Subject: Blackbuck Resources, LLC; Republic SWD #1 (SWD-2678; pEG2528352412)
C-108 Supplemental Submittal

The purpose of this letter is to submit supplemental information associated with Blackbuck Resources, LLC's (Blackbuck) C-108 application for the proposed Republic SWD #1 (SWD-2678; pEG2528352412). This information is being provided to address OCD's comments in a recent Administrative Completeness Checklist. A list of the updates to the application is included below.

Republic SWD #1

Proposed Wellbore Diagram

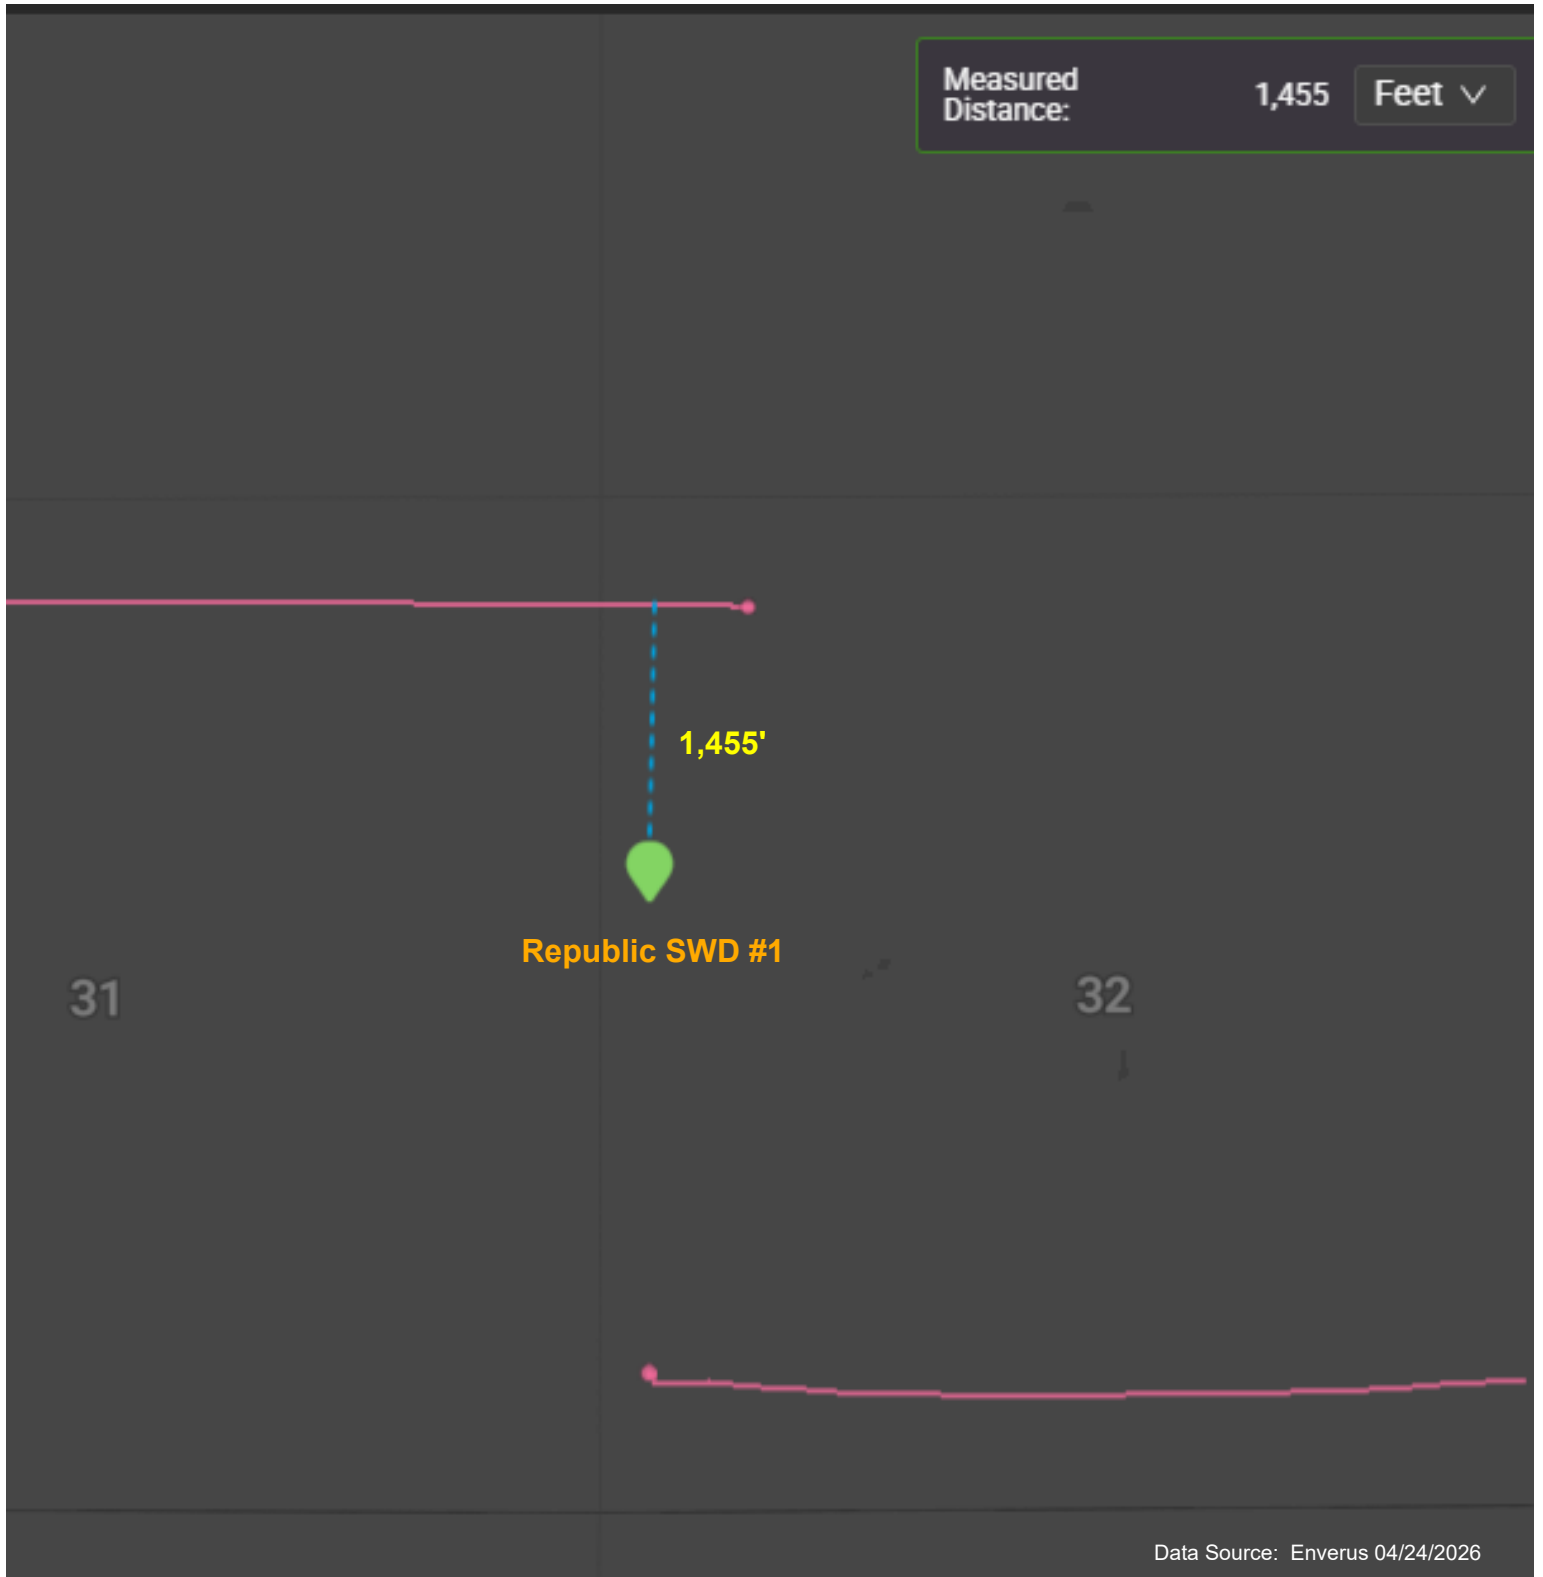
- **Revise from Open-Hole to Cased-Hole:** Revised completion from Open-Hole to Cased-Hole and updated the liner depth and cement volumes in the Tabulated Casing Data and Wellbore Diagram (WBD) accordingly.

- see **Attachment A** for Updated Tabulated Casing Data (p. 3) and Updated WBD (p. 5)
- **No Underlying USDW Statement:** Added a Statement to the Geology Data clarifying that "No USDWs were identified underlying the proposed injection interval."

Casing Size: 7-5/8 in
Casing Type: 29.7 lb/ft HCL-80
Casing Depth: 9,459 ft - 13,790 ft
Hole Size: 8-3/4 in
Top of Cement: 9,570 ft
Sks Cement: 318 sx
Cement Type: Class C

Formation(s): Devonian-Silurian
Top: 12,589 ft
Bottom: 13,790 ft
Hole size: 7-5/8 in
Cased or Open-Hole: Cased-Hole
